Addendum

SPRINGS AT FREMAUX TOWN CENTER
SLIDELL, LA

DRAWING TITLE FIRST FLOOR PLAN - CLUBHOUSE

FIRST FLOOR PLUMBING PLAN - CLUBHOUSE
SCALE: 1/8" = 1'-0"

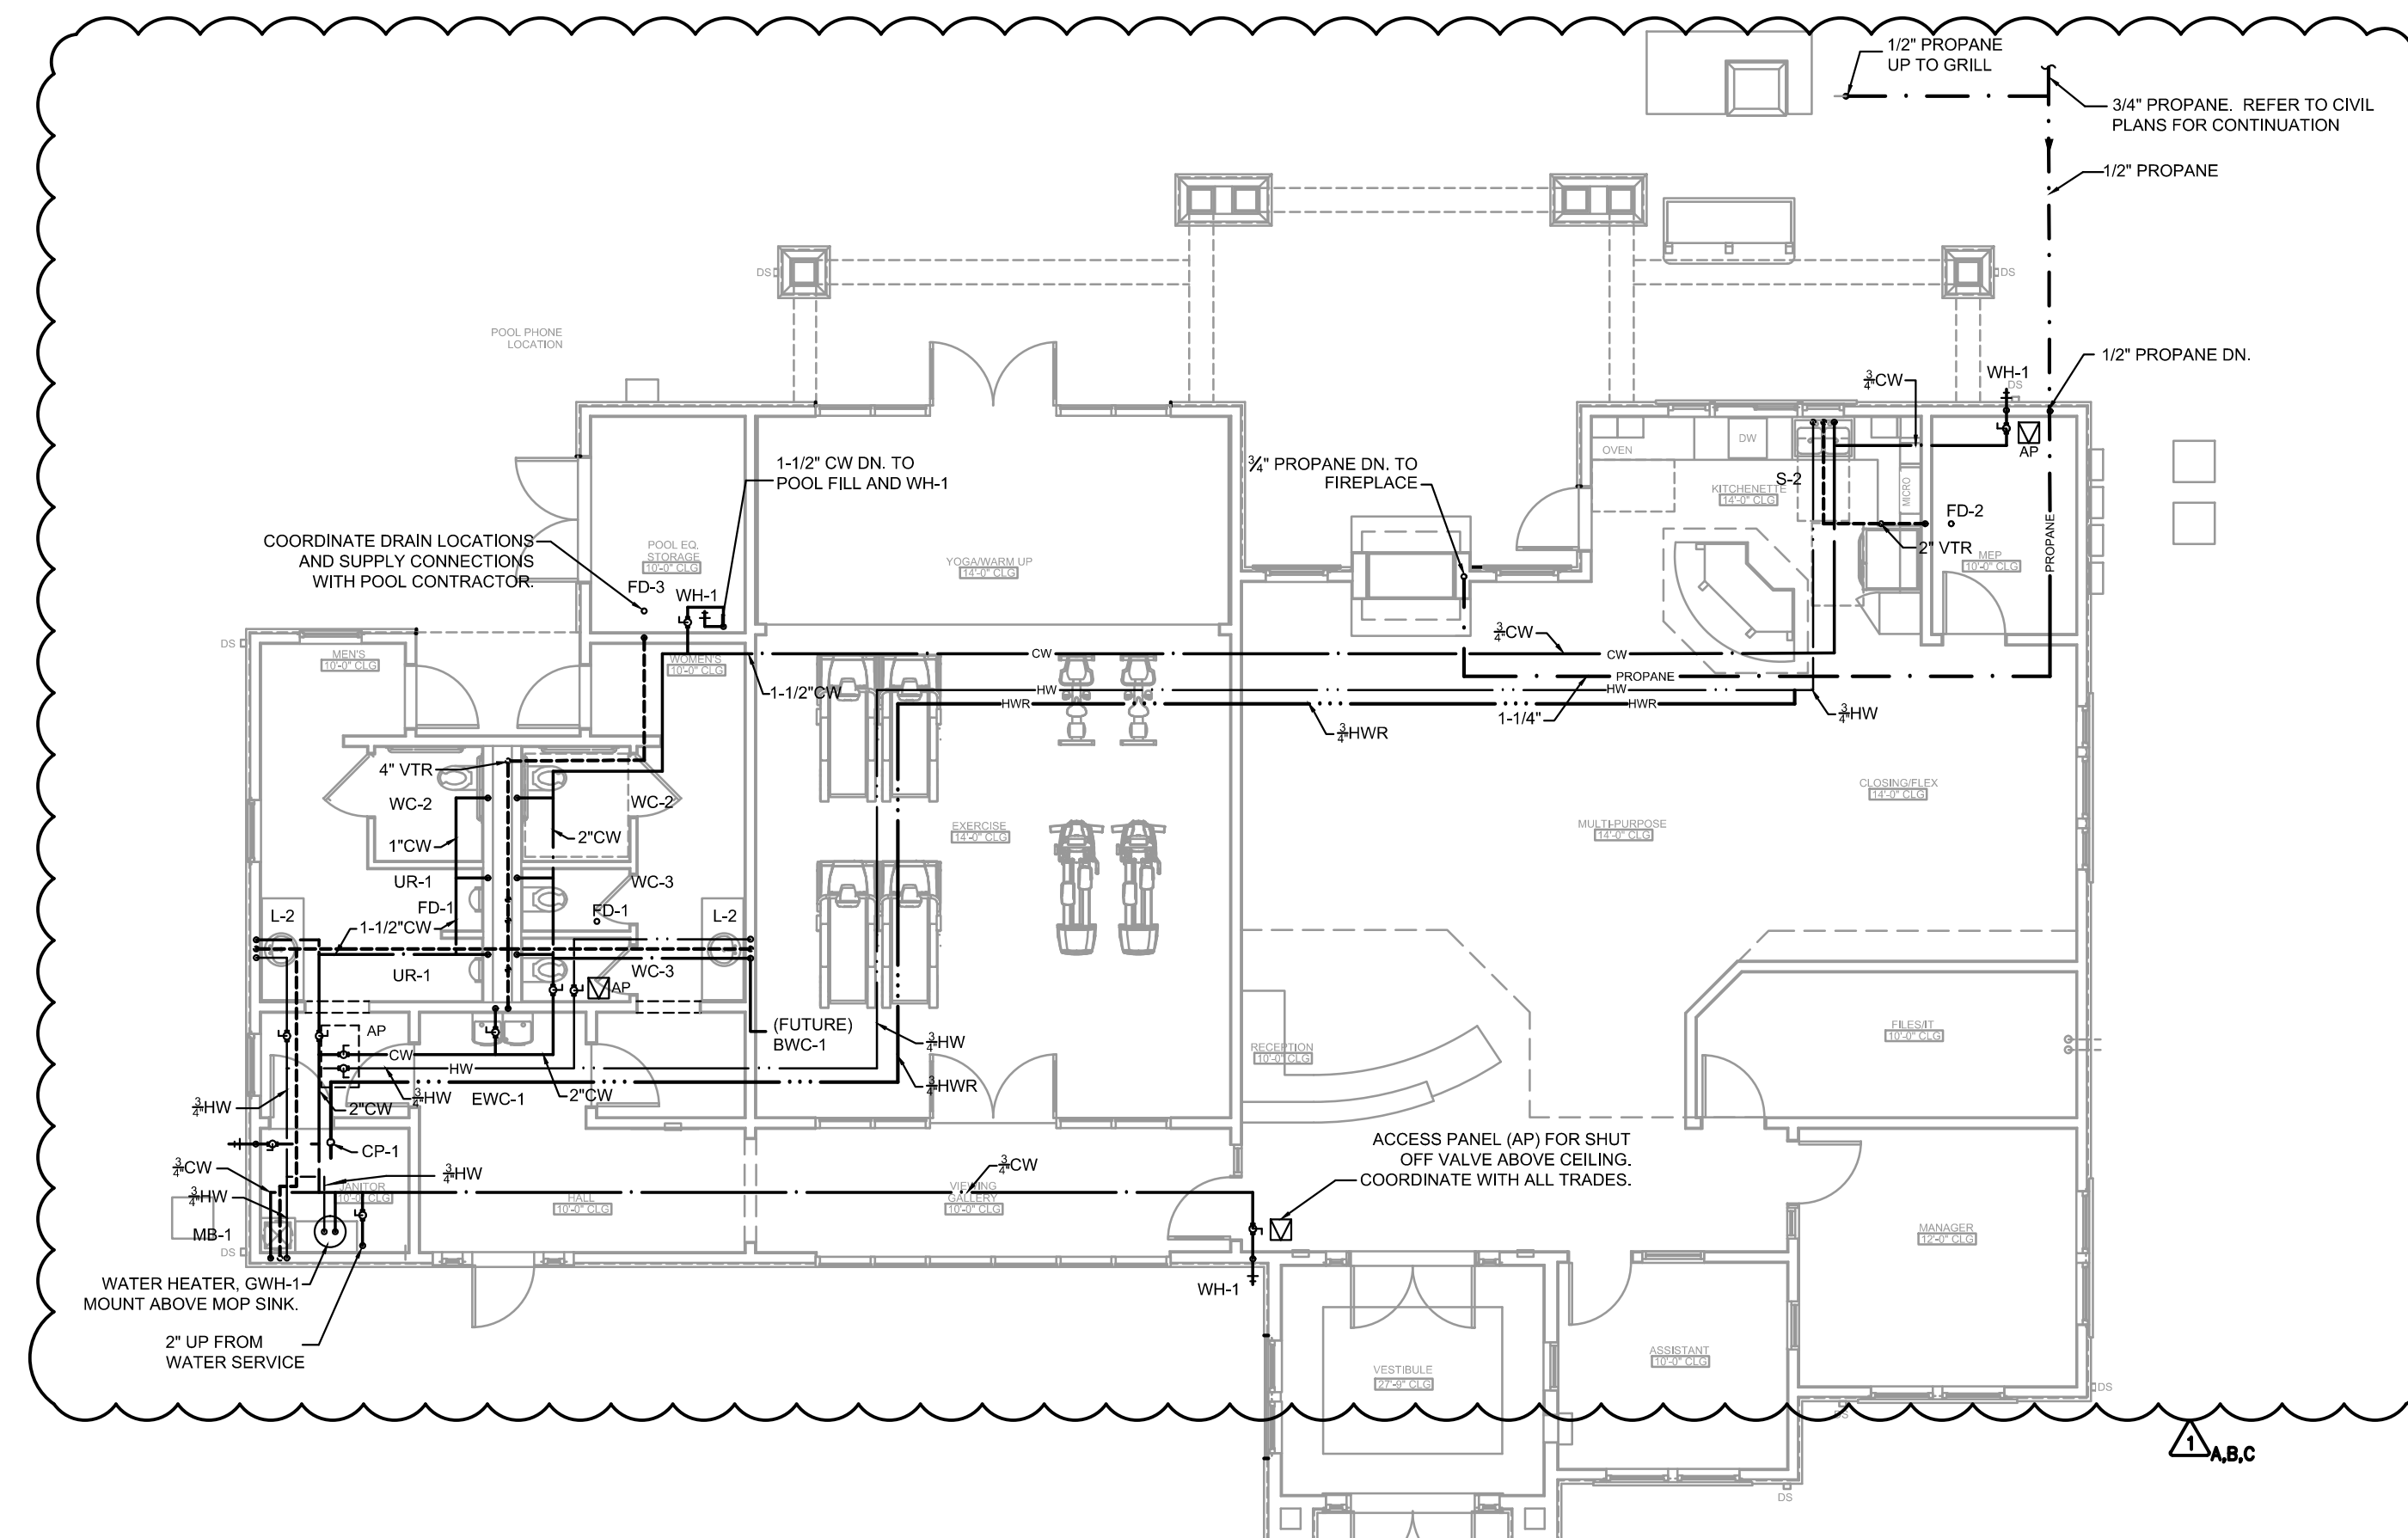
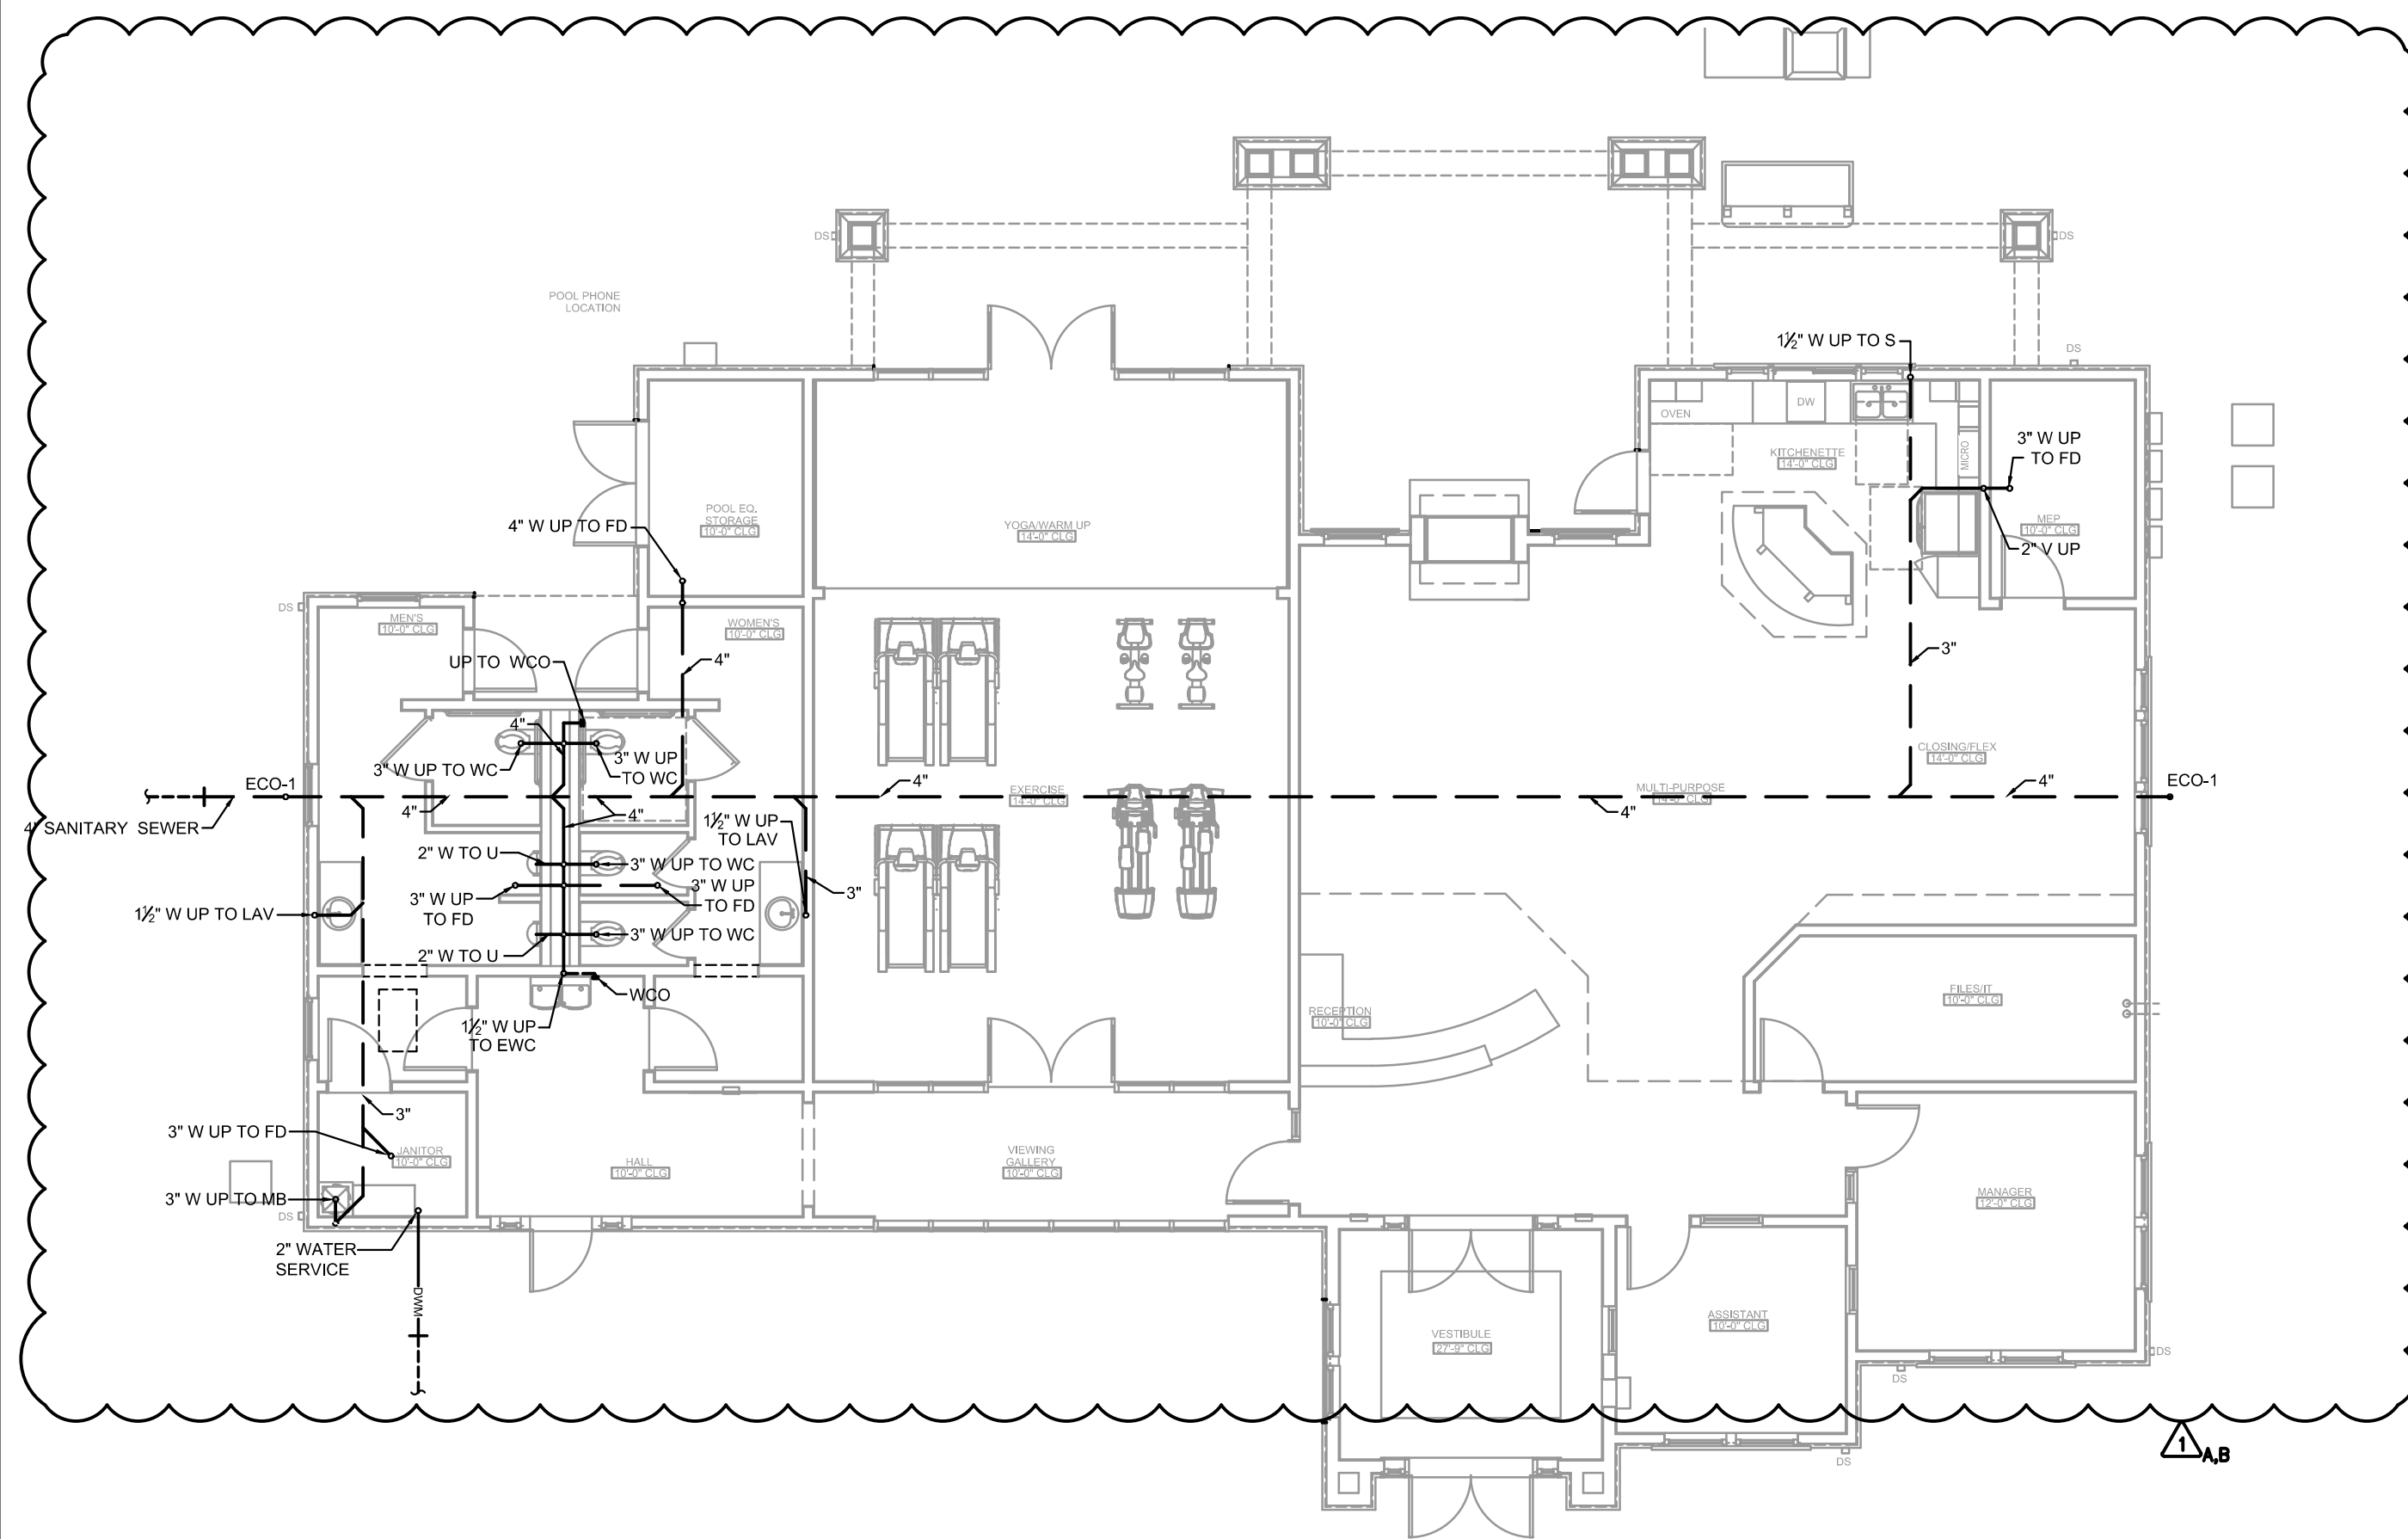
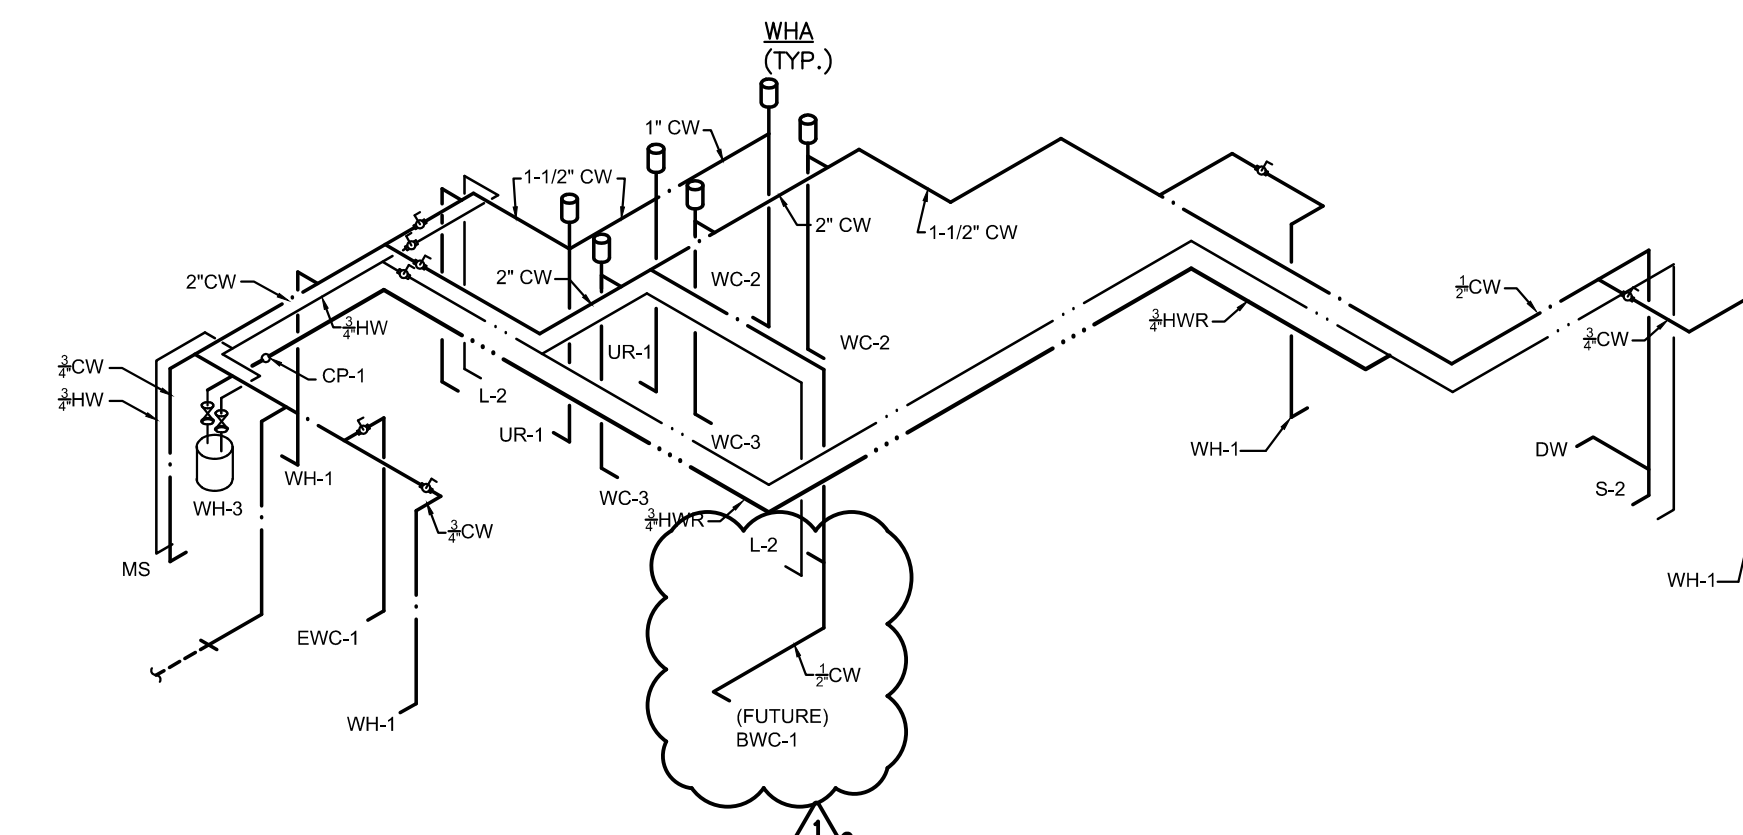
- A. REVISED GAS LINES FOR PROPANE
- B. REVISED PLUMBING PER REVISED BASE PLAN
- C. ADDED WATER LINE FOR FUTURE BOTTLELESS WATER COOLER
